FIELD ADVISORY

FA#95-005 Revised
May 31, 1995

SUBJECT: Replacing U601 On 86XX Mobile Radios

Older 8600/01/02/04/22/25/40/44 U601 Board Layout
R619 Soldered From Pin 4 U601 to Nearby Trace
Figure 1

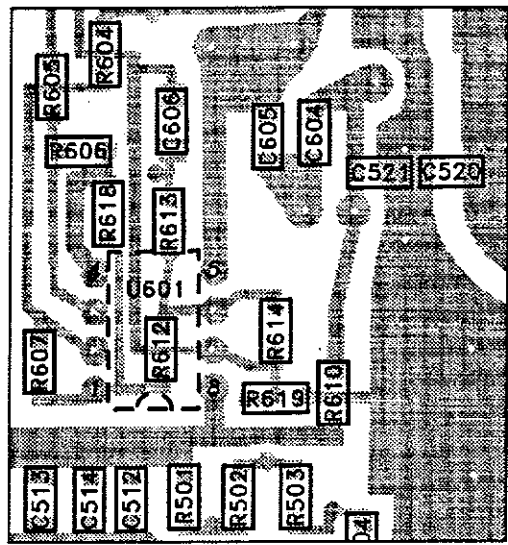
If the 10K Ω resistors (R618 & R619) described in the previous paragraph are not present on the board layout (see figure 2 on the last page), then the main radio PC board is an older version. When changing U601 to a device with a part number of 544-2019-003 on an older version board, an add-on 10K Ω chip resistor (*pn 569-0115-103*) will need to be installed on the bottom side from pin 4 of U601 to the adjacent trace that goes to pin 7 of U601. This 10K Ω resistor is used as the pull-down resistor (R619) for the output of the second stage of U601. To install this resistor, it will be necessary to scrape away some of the green solder resist on the trace that is going to pin 7 before it will be possible to solder both ends of the chip resistor. The resistor will need to be installed at an angle. See figure 1 on the last page for more details on the proper placement of R619.

Newer 8600/01/02/04/22/25/40/44 U601 Board Layout
R618 & R619 are laid out on the board
Figure 2

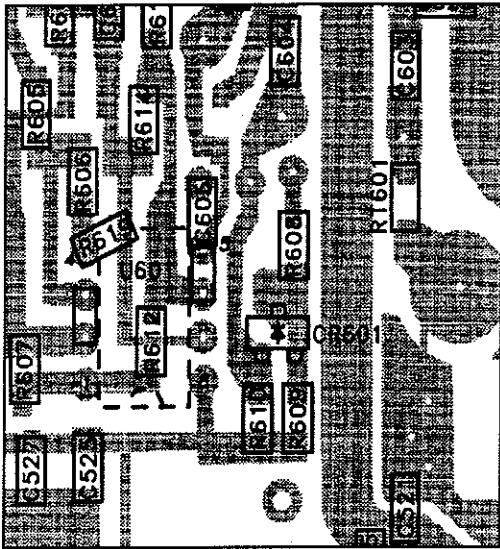
New version main radio PC boards incorporate the 10K Ω pull-down resistors on the board layout. This newer board has a 10K Ω chip resistor (R619) located near pin 8 of U601 (pin 7 pull-down resistor) and a 10K Ω chip resistor (R618) located near pin 4 of U601 (pin 1 pull-down resistor). If these resistors are present on the main PC board, then the replacement device can be installed with no further modification necessary. For more details on the layout differences in the U601 area between the newer and older main PC board, see figures 1 and 2 on the last page.

Older 8605/06/10/15/16/20/21 U601 Board Layout
R619 Soldered From Pin 4 U601 to Nearby Trace
33 pf chip caps. added as required from pins 2 to 3 and pins 5 to 6
C605 shown in its new location coming off pin 5 of U601
Figure 3

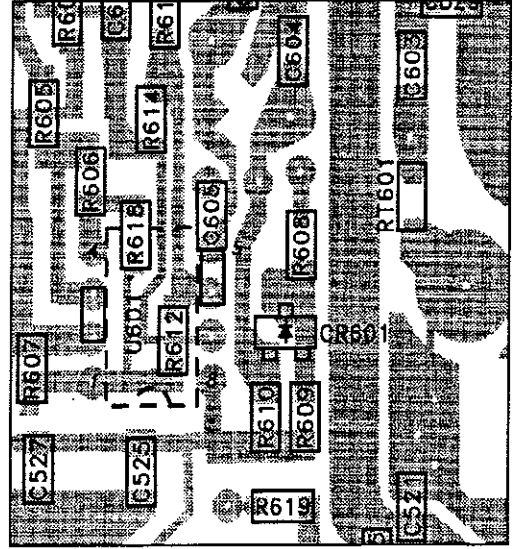
1. If the replacement op-amp has a part number of 544-2019-003 and **does not** have a Motorola® vendor marking, two 33pf chip capacitors (pn 510-3601-330) will need to be installed on the bottom of the main PC board. Install one between pins 2 and 3 of U601 and install the other between pins 5 and 6 of U601.
2. Additionally, this new configuration requires that bypass capacitor C605 (pn 510-3602-560) be relocated from its original position to a location closer to U601. One side of C605 should be soldered to pin 5 of U601 and the other to the ground side of C608.

If the 10K Ω resistors (R618 & R619) described in the previous paragraph are not present on the main PC board layout (see figure 4 on the last page), then the board is an older version. When changing U601 to a device with a part number of 544-2019-003 on an older board, an add-on 10K Ω chip resistor will need to be installed on the bottom side from pin 4 of U601 to the adjacent trace that goes to pin 7 of U601. This 10K Ω resistor is used as the pull-down (R619) for the output of the second stage of U601. To install this resistor, it will be necessary to scrape away some of the green solder resist on the trace that is going to pin 7 before it will be possible to solder both ends of the chip resistor. The resistor will need to be installed at an angle.

Newer 8605/06/10/15/16/20/21 U601 Board Layout
R618 & R619 are laid out on the board
33 pf chip caps. added as required from pins 2 to 3 and pins 5 to 6
C605 shown in its new location coming off pin 5 of U601
Figure 4

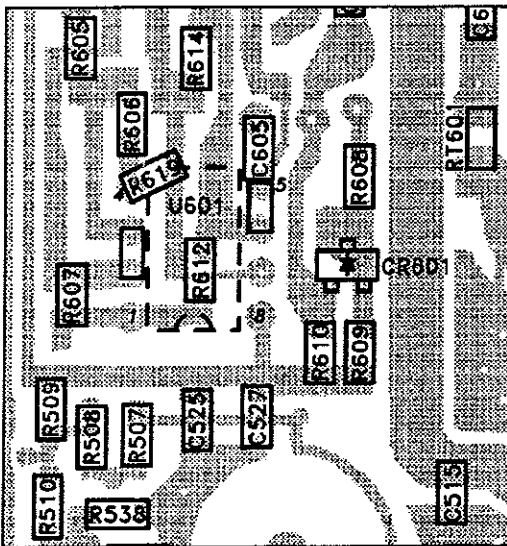
All above listed radio models with a build date of early July, 1994 or later, will likely have the newer main PC board. These newer boards incorporate the 10K Ω pull down resistors on the board layout. The newer board has a 10K Ω chip resistor (R619) located near R610 and R609. R619 is the pull-down resistor for U601 pin 7. Another 10K Ω chip resistor, R618, is located near pin 4 of U601. R618 is the pull-down resistor for U601 pin 1. If these resistors are present on the main PC board, then the replacement device can be installed without the need of installing pull-down resistors.

Older 8655 U601 Board Layout
R619 Soldered From Pin 4 U601 to Nearby Trace
33 pf chip caps. added as required from pins 2 to 3 and pins 5 to 6
C605 shown in its new location coming off pin 5 of U601
Figure 5

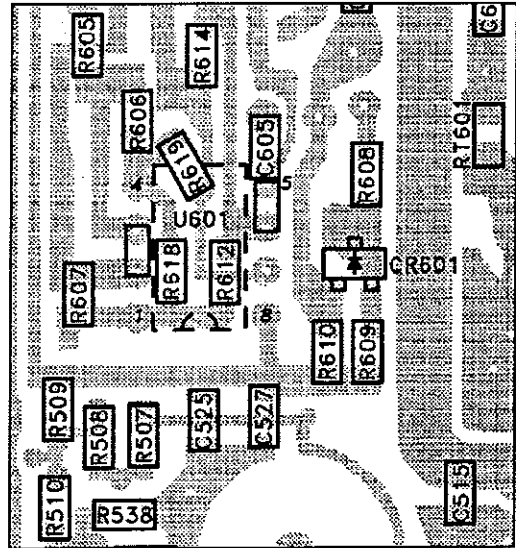
If the 10K Ω resistors (R618 & R619) described in the previous paragraph are not present on the main PC board layout (see figure 6 on the last page), then the board is an older version. When changing U601 to a device with a part number of 544-2019-003 on the older board, an add-on 10K Ω chip resistor will need to be installed on the bottom side from pin 4 of U601 to the adjacent trace that goes to pin 7 of U601. This 10K Ω resistor is used as the pull-down (R619) for the output of the second stage of U601. To install this resistor, it will be necessary to scrape away some of the green solder resist on the trace that is going to pin 7 before it will be possible to solder both ends of the chip resistor. The resistor will need to be installed at an angle.
